Project	<b>IEEE 802.16 Broadband Wireless Access Working Group</b> < <a href="http://ieee802.org/16">http://ieee802.org/16</a> >	
Title	<b>Proposed change on downlink control for multicast communication over IEEE 802.16.1a</b>	
Date Submitted	<b>2012-03-06</b>	
Source(s)	Eunkyung Kim, Sungkyung Kim, Sungcheol Chang, Won-Ik Kim, Seokki Kim, Miyoung Yun, Hyun Lee, Chulsik Yoon, Kwangjae Lim  ETRI	Voice: +82-42-860-5415  E-mail: <a href="mailto:ekkim@etri.re.kr">ekkim@etri.re.kr</a>  <a href="mailto:scchang@etri.re.kr">scchang@etri.re.kr</a>
Re:	“IEEE 802.16-12-0142,” in response to Letter Ballot #38 on P802.16.1a/D1	
Abstract	Downlink control for multicast operation on GRIDMAN Draft Standard	
Purpose	To discuss and adopt the proposed text in the draft amendment document on GRIDMAN	
Notice	<i>This document does not represent the agreed views of the IEEE 802.16 Working Group or any of its subgroups.</i> It represents only the views of the participants listed in the “Source(s)” field above. It is offered as a basis for discussion. It is not binding on the contributor(s), who reserve(s) the right to add, amend or withdraw material contained herein.

# Proposed change on downlink control

Figure 1—number of connections for multicast communication using HR Multicast DL Assignment A-MAP IE in 10MHz system bandwidth (mPA: no fragmentation, mDA: fragmentation)

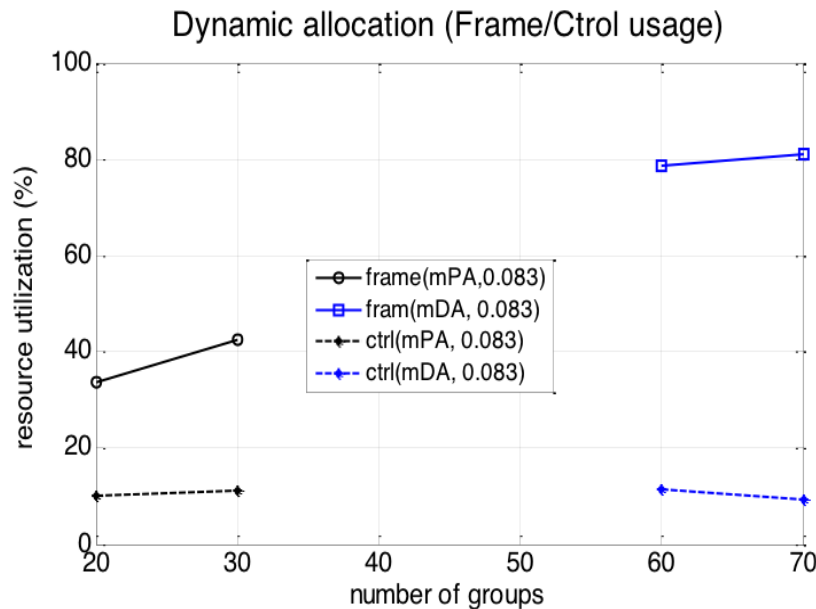
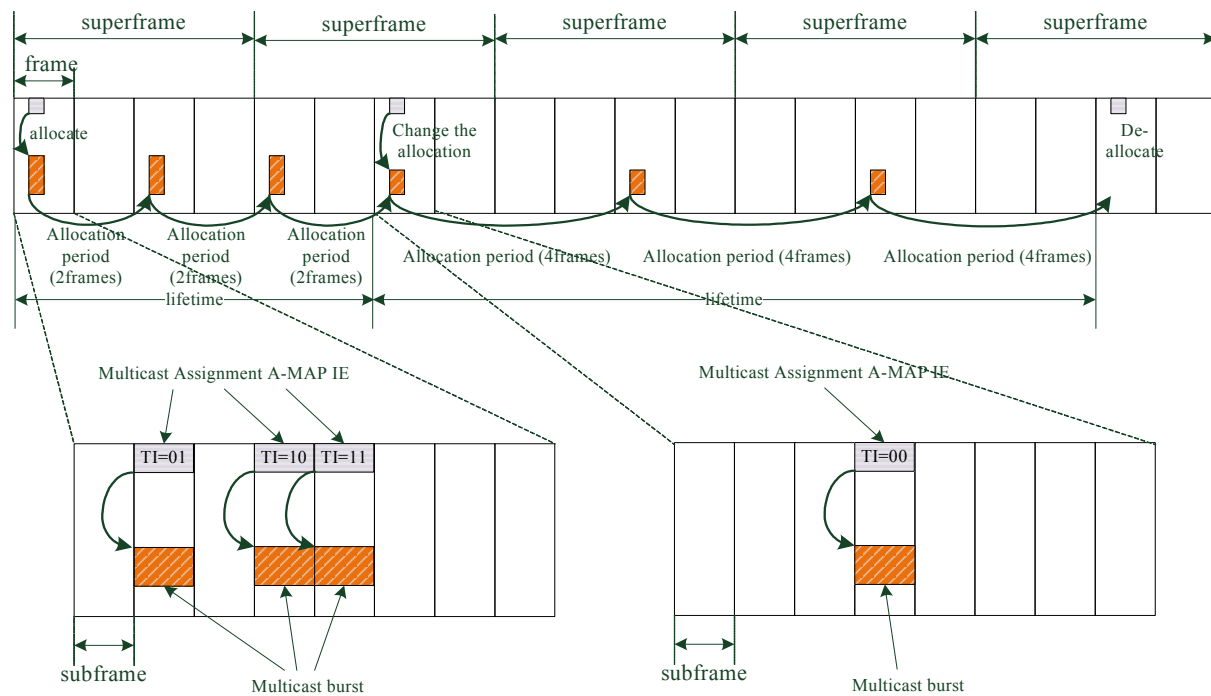
Figure 1 shows the number of connections for multicast communications using HR Multicast DL Assignment A-MAP IE. As shown the figure, number of connections using fragmented transmission is larger than that without fragmented transmission due to variable reason such as limit of resource in a subframe and level of MCS.

Thus, we propose a change on the downlink control for multicast communication (i.e., HR Multicast DL Assignment A-MAP IE).

Current HR Multicast DL Assignment A-MAP defined in P802.16.1a/D1 is transmitted persistently without fragmentation. To provide fragmented transmission of multicast traffic, the transmission indication is proposed and it indicates whether additional traffic is transmitted after transmission of multicast traffic in the time of allocation period. Transmission indication has 2bit information as follows:

- 0b00: no fragment
- 0b01: first fragment
- 0b10: continue
- 0b11: last fragment
